California Water Research Technical Memo

July 2018

Dr. Clyde Thomas Williams

Under-Seepage and Seismic Safety Issues at Clifton Court Forebay

1 Assessor's Map showing Clifton Court LLP property Source: Exhibit CCLP-11

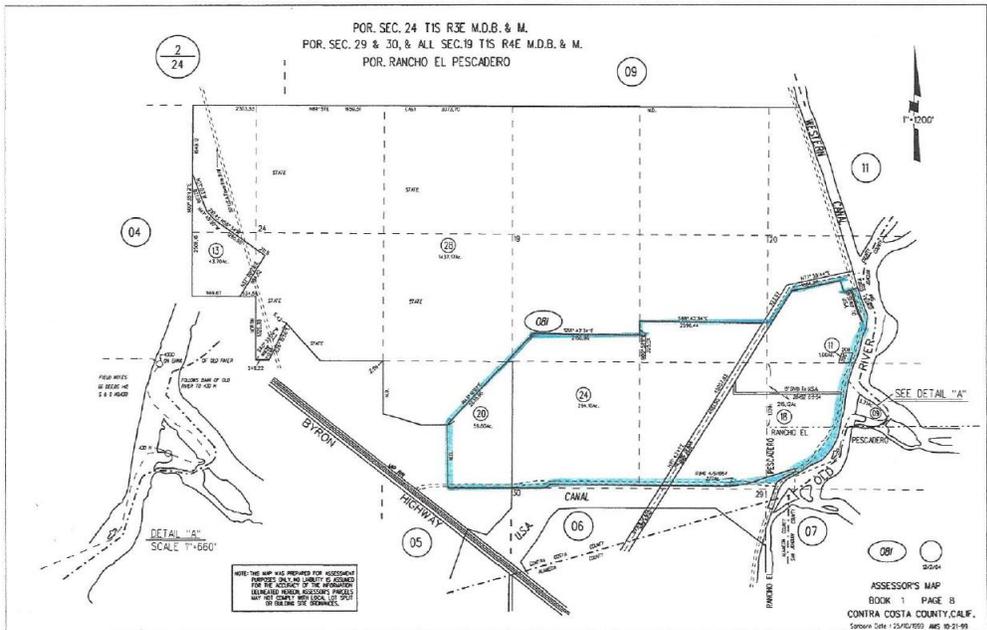
Suzanne Womack, a partner in Clifton Court LLP, has reported ongoing seepage on land next to Clifton Court Forebay to the State Water Resources Control Board in the WaterFix Change Petition Hearing. Ms. Womack testified in the Hearing that seepage started after the Forebay was constructed, and has continued. She stated that seepage severely impaired 25 acres during the drought, and impaired another 15 acres. The area of impairment reportedly expanded in 2017. Ms. Womack states that after talking to her tenant farmer, she believes seepage may be affecting up to 70 acres. Ms. Womack called the Delta Field Division of the Department of Water Resources in 2017 to report the seepage. As described below, the resulting investigation appears to have been cursory and inadequate, given that under-seepage is a failure mode for the Forebay embankment.

2 Closeup of Clifton Court Forebay

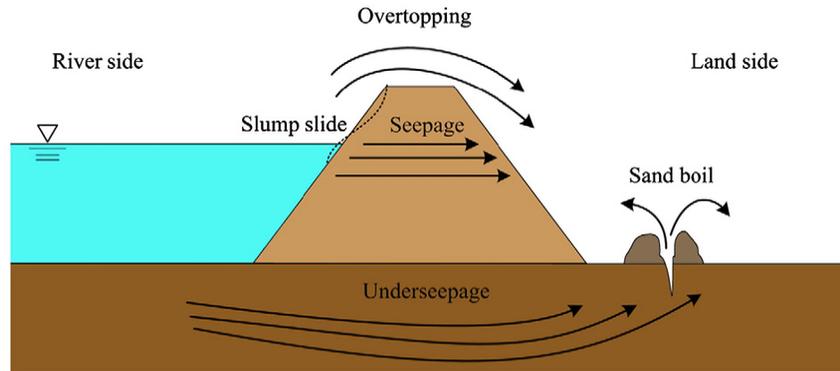
Specifically, DWR staff inspected our pump station that is near your property and identified as "seep 6" on the attached map. The inspection found that the seep pump, the seep well, and the standing groundwater within our seep basin is fully operational and operating efficiently. The seep basin is currently at the level it is supposed to be.

DWR's Delta Field Division did not provide any project design, operating conditions, or other explanations of why "normal water" levels in the seep basin would be inconsistent with under-seepage onto Ms. Womack's property and potential seepage flows, nor was information provided about seepage flow rates and paths to the seepage drain.
